CHATHAM COUNTY PURCHASING DEPARTMENT

ADDENDUM NO. 1 TO RFP #18-0045-5

**FOR: FIRING RANGE LEAD ERADICATION AND REFURBISHMENT FOR THE
CHATHAM COUNTY SHERIFF'S OFFICE**

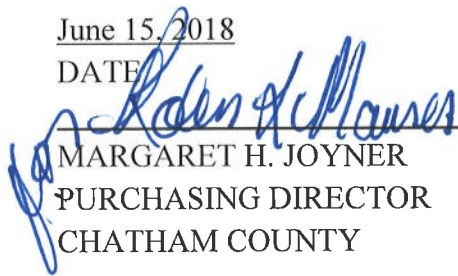
1. **CHANGE:** Section 5.2.3 shall read:

“Contractor shall restore soil in berms. The height of the berms is to be 15 feet above the ground and the slope of the berm is to be 1.5:1 or 33-34 degrees. The side berm height will be 10 feet and the slope of the berm is to be 1.5:1 or 33-34 degrees. The side berm will connect with the back main berm with sod or grass seed and erosion control mat. The left side berm on range 5 will be 10 feet and the slope of the berm is to be 1.5:1 or 33-34 degrees. All berms shall have sod or grass seed and erosion control mats. “
